Subject: FW: Coleambally Solar Farm - Drainage channel

From: Nicole Brewer [mailto:nicole.brewer@planning.nsw.gov.au]
Sent: Thursday, 31 August 2017 5:40 PM
To: Anne Frederic <anne.frederic@neoen.com>
Cc: Tim Stuckey <Tim.Stuckey@planning.nsw.gov.au>; Clay Preshaw <Clay.Preshaw@planning.nsw.gov.au>
Subject: Coleambally Solar - More Information Required

Name : Proposed subdivision of lots 100 and 101 in DP750896
Project : Coleambally Solar Farm
Date : 4 September 2017

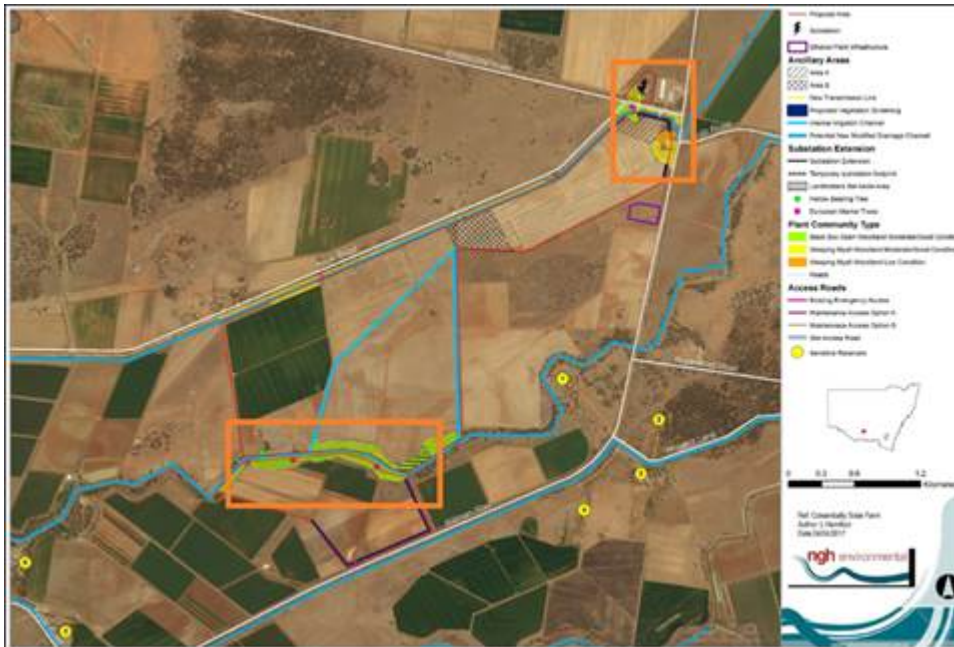
3. Substation: confirm the following and if they are part of your application:

- the temporary substation footprint : This is the area that will be temporary used during the substation extension construction (e.g. material handling)
- the substation extension : This refers to the extension of the existing bench of the substation to accommodate the new connection infrastructure (see p.17 and p 23 of the EIS)
- borrow pit : Some material might be taken from the existing borrow pit on site to form the bench of the substation, therefore it was included in the EIS (sections 7.1.2, 3.2)
